**Ref: SSD-78156462**

**RE: SUBMISSION TO SSD-81890707 10, 14 AND 14A STANHOPE ROAD KILLARA**

Following a review of the revised documentation, Council maintains its **objection** to the proposed development. Council's submission is contained in **Attachment 1**.

**Figure 5: Shadow diagram at 2pm midwinter**

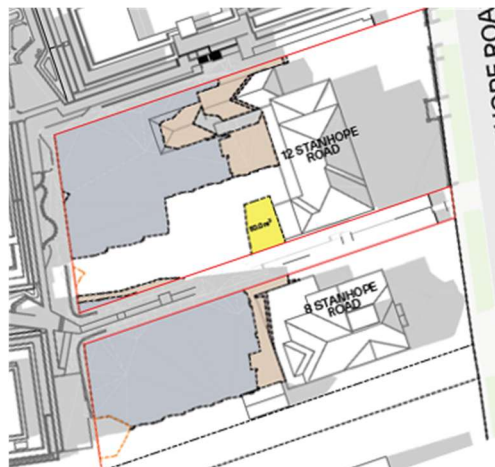
<b>Design Principles</b>	
Building massing	<p>It is acknowledged that the upper floor of Building B has been deleted and that the setbacks of Level 7 of Building C have been increased. Given the scale of the development, these amendments are comparatively minor in nature and do not make any appreciable reduction in bulk impacts to adjoining low density development at Nos. 8 and 12 Stanhope Road (compare <b>Figures 3 and 4</b> below).</p> <p>As detailed in the Heritage comments below, a further reduction in building height and a significant increase in setbacks is required to mitigate impacts to the heritage item.</p>  <p><b>Figure 3: West Elevation, original proposal</b></p>  <p><b>Figure 4: West Elevation, amended proposal</b></p>
Adverse amenity impacts	<p>Concerns were raised previously in relation to excessive apartment depth and inadequate building separation. These issues appear to be unresolved. Further, the architectural plans contain insufficient information for assessment with no notations for boundary setbacks or separation provided.</p> <p>It was noted previously that no analysis of the impacts of the development on adjoining properties has been provided. The amended proposal includes Sun Eye View diagrams showing modelling based on 'Low and Mid Rise Housing' (architectural plans DA604-DA0606). The accuracy of this modelling is unclear as the adjoining sites are located within the 'Low and Mid Rise Housing Exclusion Map' under SEPP Station Precincts. Accordingly, development under Chapter 6 of SEPP Housing is not permissible on these sites. The consent authority should seek clarification and correction in relation to this modelling.</p> <p>Overshadowing to adjoining properties zoned for low density development remains unacceptable. The amended diagrams demonstrate that 4 hours of solar access is retained to only a small portion of the rear yard of No. 12 Stanhope Road (50m<sup>2</sup> shown yellow in <b>Figure 5</b>). This is not an accurate representation of the private open space of this property which includes a tennis court, turfed area and swimming pool (<b>Figures 6 and 7</b>). In reality, the majority of the private open space of this property will be overshadowed by the proposed development for the majority of the day (e.g. the tennis court will be overshadowed from 10am to 3pm). Consequently, the development fails to satisfy Schedule 9 Design Principle 6: Amenity of SEPP Housing.</p>

**Figure 10: Excerpt from stormwater plans**

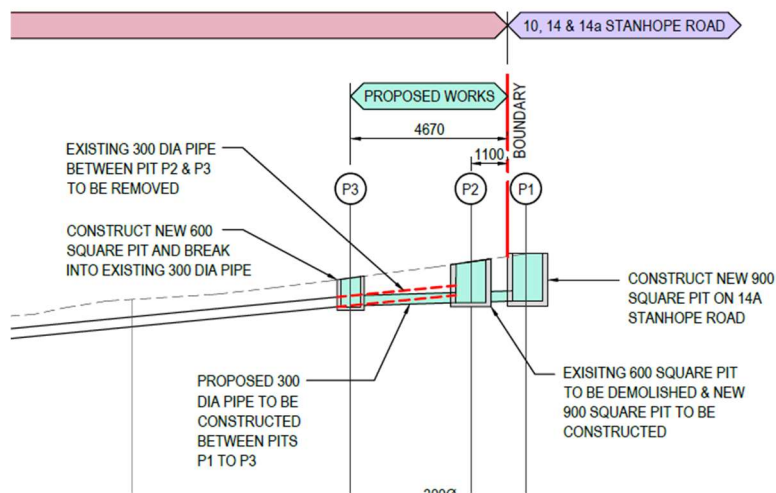
<b>BASIX</b>	
Indigenous planting not indicated on plans	The area of proposed indigenous planting of 515m <sup>2</sup> is not indicated on the plans in accordance with the BASIX certificate requirements. No amended BASIX certificate/s have been submitted. The amended proposal includes a BASIX report (not certificate).
<b>Water management</b>	
Owner's consent	<p>The Response to Submissions Report indicates that discussions have been undertaken with the owners of No. 10-14 Marian Street regarding an easement yet consent is yet to be granted for the easement.</p> <p>A sketch plan of the proposed easement to drain water has been provided for discussion purposes. It is noted that this proposal relies on all proposed stormwater infrastructure being utilised (if existing) or constructed within the proposed easement being within 1.8m of the western boundary of the common property of SP80433. Owners' consent from the Strata Corporations has yet been provided.</p> <p>If physical works are proposed on an adjoining property, it is Council's view that consent from the neighbouring property owner is to be provided at lodgement for the making of the application (section 23 of <i>Environmental Planning and Assessment Regulation</i>). As currently proposed, physical works are proposed on an adjoining property (<b>Figure 10</b>) and owner's consent has not been provided.</p>

Concern was previously raised in relation to the submission of insufficient information to enable an assessment of water management. Specifically:

- a) *The application has not provided sufficient information as to enable assessment of the inter-allotment drainage design through No. 10-14 Marian Street, including but not limited to civil design of the pipeline and any potential impacts on trees and vegetation on adjoining properties.*

- b) *A detailed survey must be obtained to show the accurate location of the inter-allotment drainage pit within No. 10-14 Marian Street.*
- c) *Supporting hydraulic calculations are to be submitted to confirm that the pipeline to which connection is proposed has sufficient hydraulic capacity to accept the post developed flows.*

- d) *The inter-allotment drainage pipeline condition to which connection is proposed is to be checked by a licensed plumber. The design fails to adequately provide certainty that the existing pipe is functional and in working condition, including CCTV footage and accompanying report demonstrating the condition of the pipeline has not been submitted.*

A Work-as-executed plan has been submitted which confirms the location of the existing inter-allotment drainage system through No. 10-14 Marian Street. The remaining information has not been provided (items b, c and d above).
